Burnside Park Bathroom Building

ADDENDUM NO. 1

TO: All Bidders on the Above Referenced Product
FROM: Davis Purdy Architects, PLLC
DATE: March 26, 2026
SUBJECT: **ADDENDUM NO. 1**

Sheet Title
FLOOR PLAN

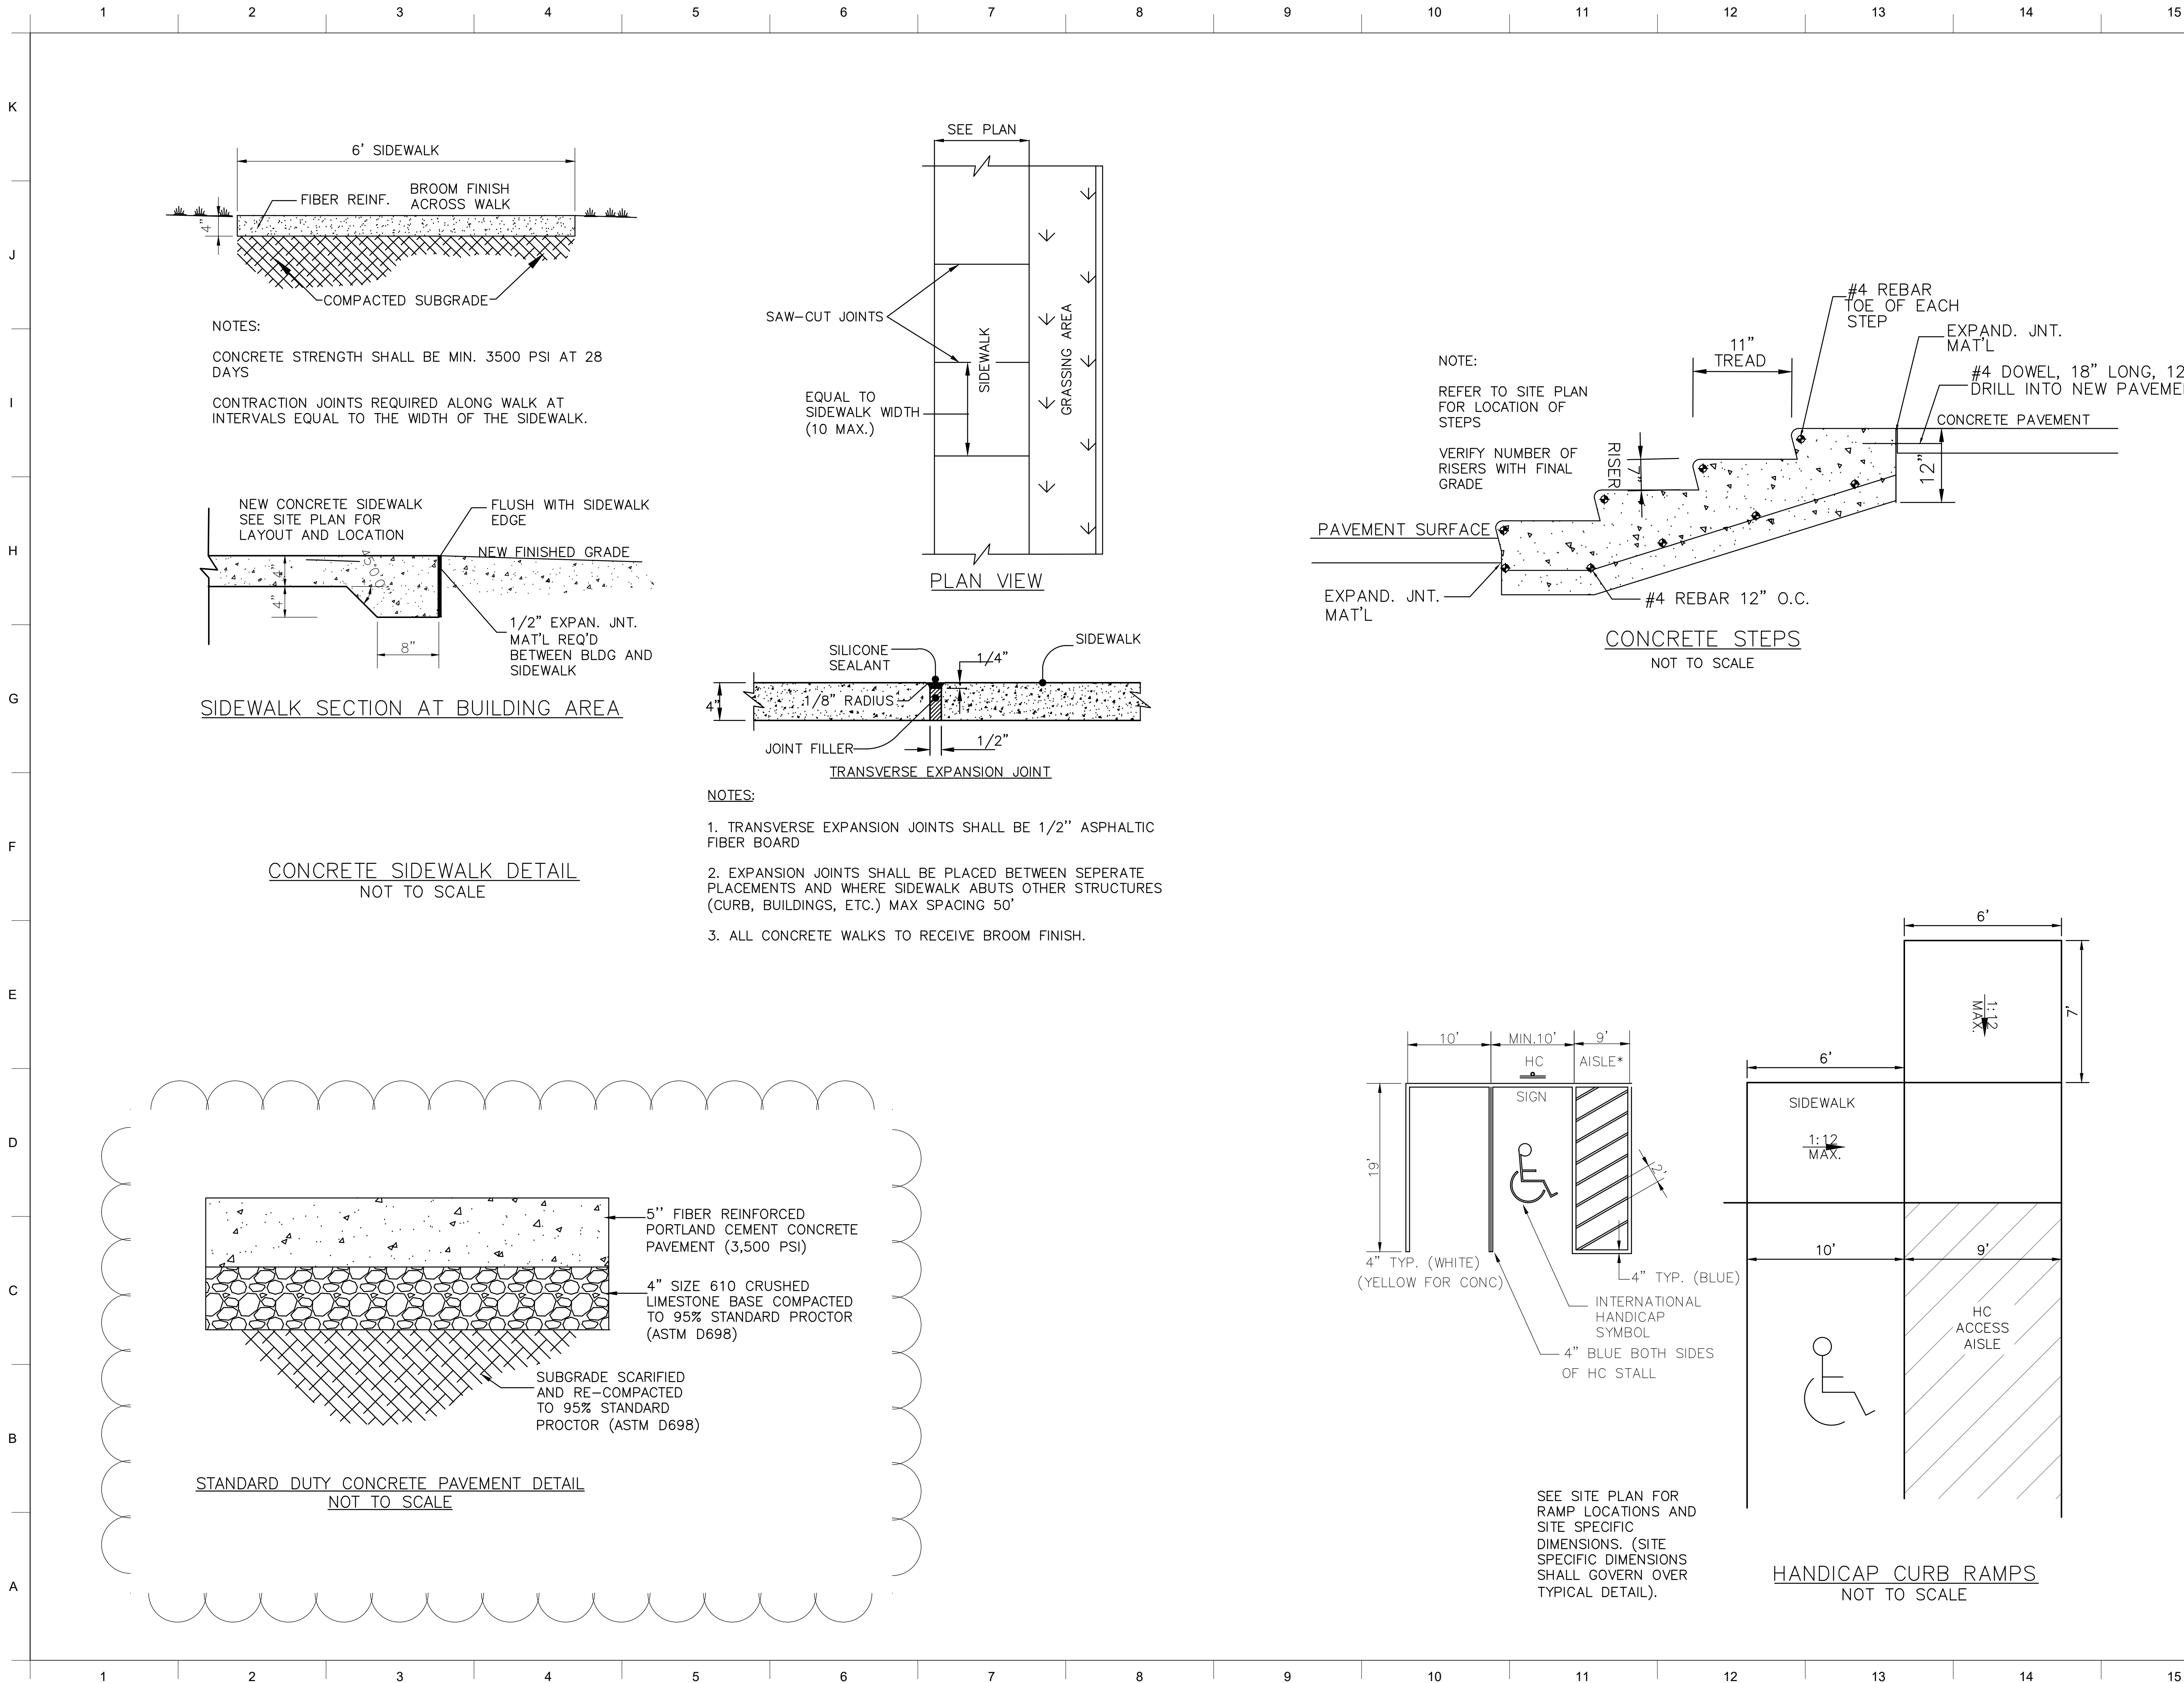
1. **ADD:** Add the **Pre-Bid Conference Meeting Minutes & Sign in Sheet**. Pre-Bid Conference Minutes are attached.
2. **ADD:** Specification section **00 60 01 – SUPPLEMENTAL CONDITIONS** dated 3/26/2026. Specification Section 00 60 01 is attached
3. **ADD:** Specification section **01 78 39 – PROJECT RECORD DOCUMENTS** dated 3/26/2026. Specification Section 01 78 39 is attached
4. **REPLACE:** Drawing **A101 FLOOR PLAN** dated 1/30/2026 with **A101 FLOOR PLAN** dated 3/26/26. Drawing A101 is attached
5. **REPLACE:** Drawing **C-600 SITE DETAILS** dated 1/30/2026 **C-600 SITE DETAILS** dated 3/26/26. Drawing C-600 is attached
6. **CLARIFICATION:** Contractor to use dimensions on the Architectural drawings in lieu of structural where discrepancies are found for the heavy timber columns. Contractor to 8" square columns shown in drawings.

7. **REPLACE:** Contractor to use Western Cedar for heavy timber trusses and column wood species in lieu of Douglas Fir
8. **CLARIFICATION:** All products & materials are required to be Build America, Buy America (BABA) approved.
9. **CLARIFICATION:** Electrical coordination study is required and will be the responsibility of the contractor to schedule and provide.
10. **REMOVE:** Remove the connection from the existing service to the transformer. Connection will be made by others. Selected contractor will need to coordinate the trenching of the roadway for placement of the fiber conduit with Central Electric to likely place the underground utility service.

- Timber Truss:
 - o Can it be built on site? **Yes**
 - o Douglas Fir? **Species to be Western Cedar in lieu of Douglas Fir, stained.**
- Discrepancies in column sizes and shapes between Arch and Structural drawings. **Columns to be 8" x8" Western Cedar to match the truss, stained**
